Thanks for the opportunity to review this latest draft of the University Place Design Standards. Below are comments addressing specific sections or pages of the standards.

**Sketch 1**

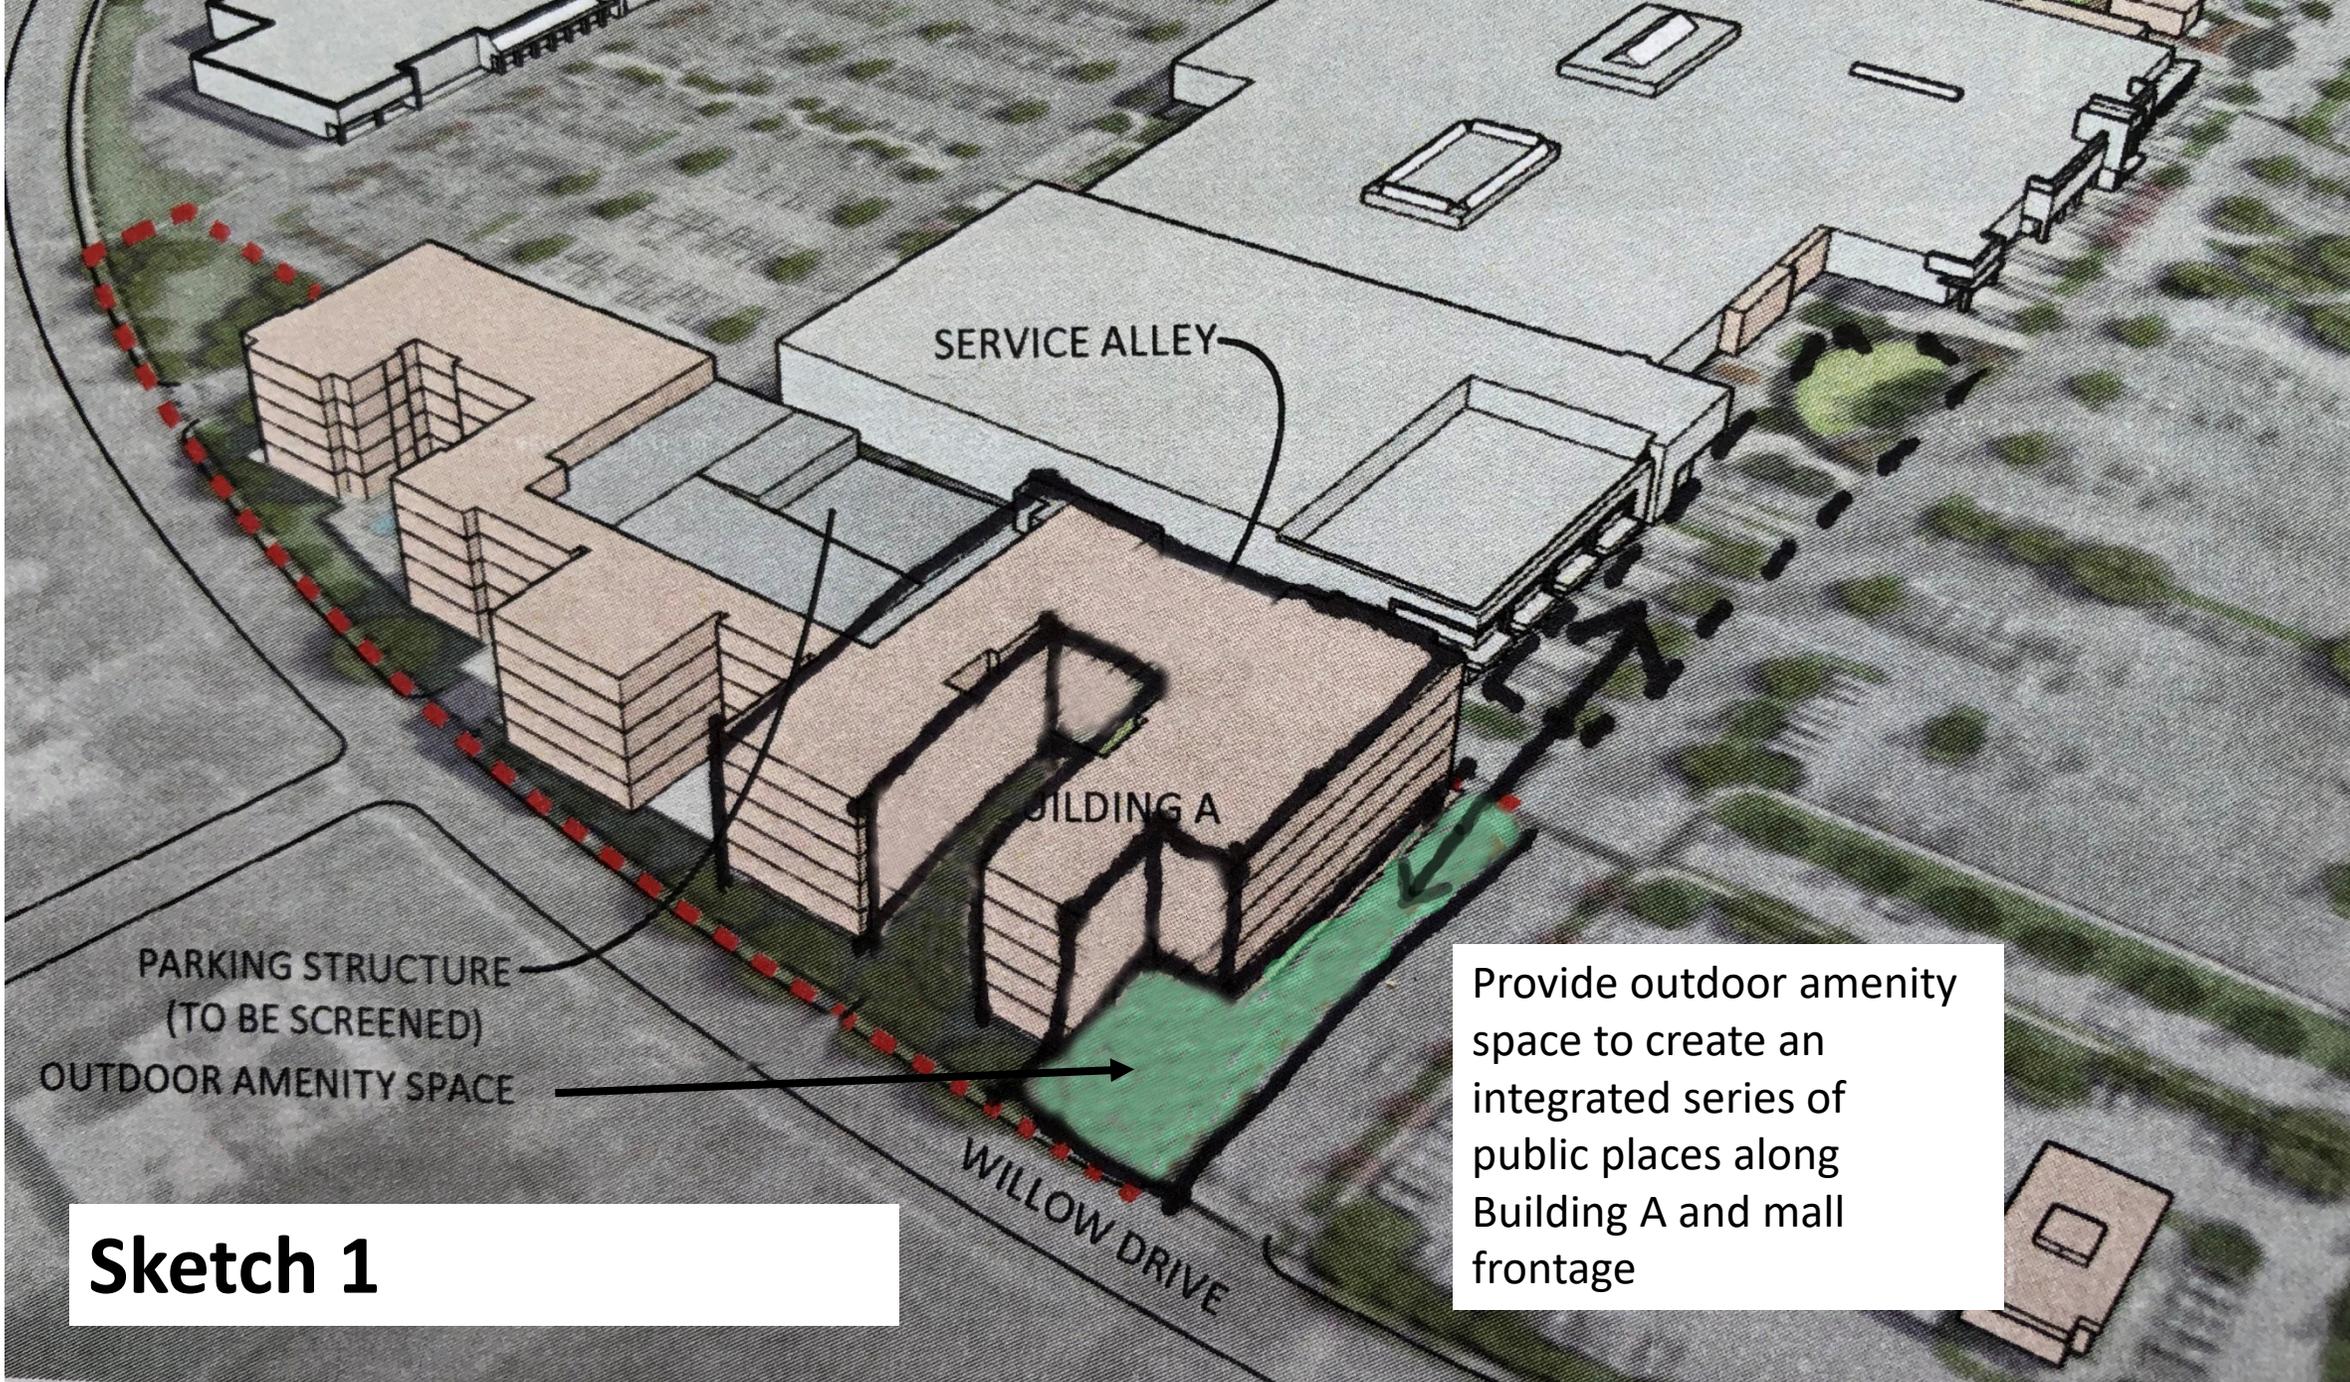
3. Sketch 1 (Pod A): Rather than providing the outdoor amenity space in a liner lawn strip along Willow Drive, suggest focusing it at the corner of Willow and the mall entrance drive, extending east to connect to the outdoor pedestrian area in front of the cinema and to the proposed new public place further east, creating an integrated series of public places connecting the community and the town center. Also, given that the proposed street between Pod A and the cinema is now considered a service street for loading and service, suggest having the conceptual Private Courtyard for Building A open up to the Willow Drive frontage, which can also serve to break down Building A’s massing along the street.

Provide outdoor amenity space to create an integrated series of public places along Building A and mall frontage

**Sketch 2**

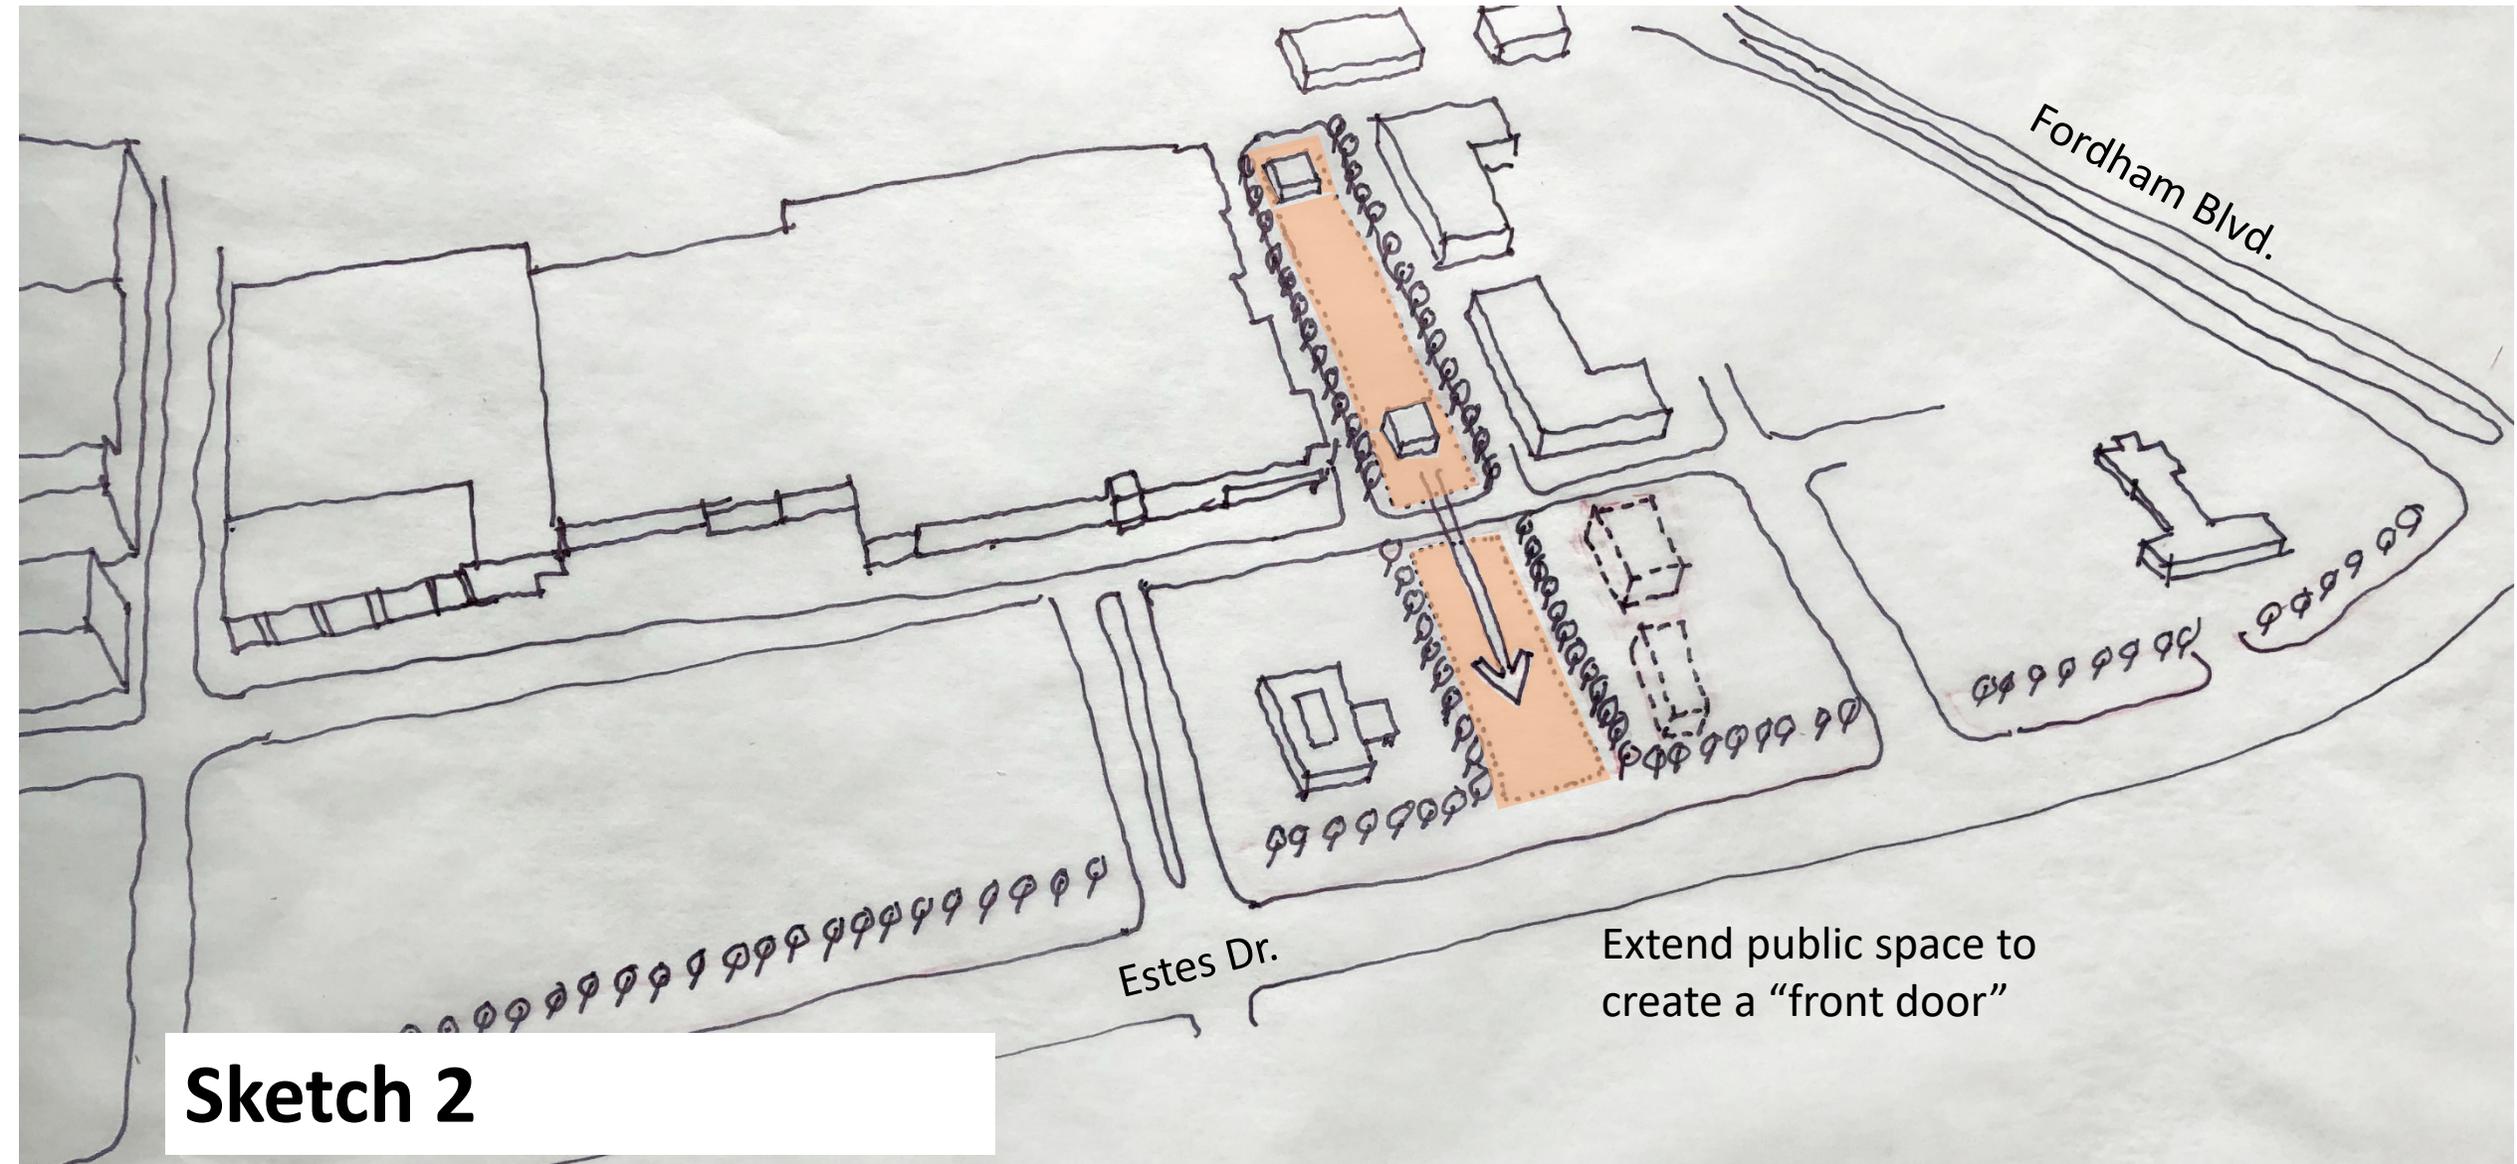
4. Sketch 2 (Pod D): Suggest looking for ways to make it seem like the central park/green space/plaza in Pod “C” extends southward to Estes. The character of this space could take various forms. It could be green space, a plaza, or a combination of both. Another possibility would be for it to still accommodate some parking, but feature some decorative paving and landscape that would allow the area to become a kind of “mixed use” parking lot, where a farmer’s market or other occasional gathering could occur. Whatever its character becomes, it is suggested that proposed new buildings A & B be located along this extension to help spatially define it.

Extend public space to create a "front door"
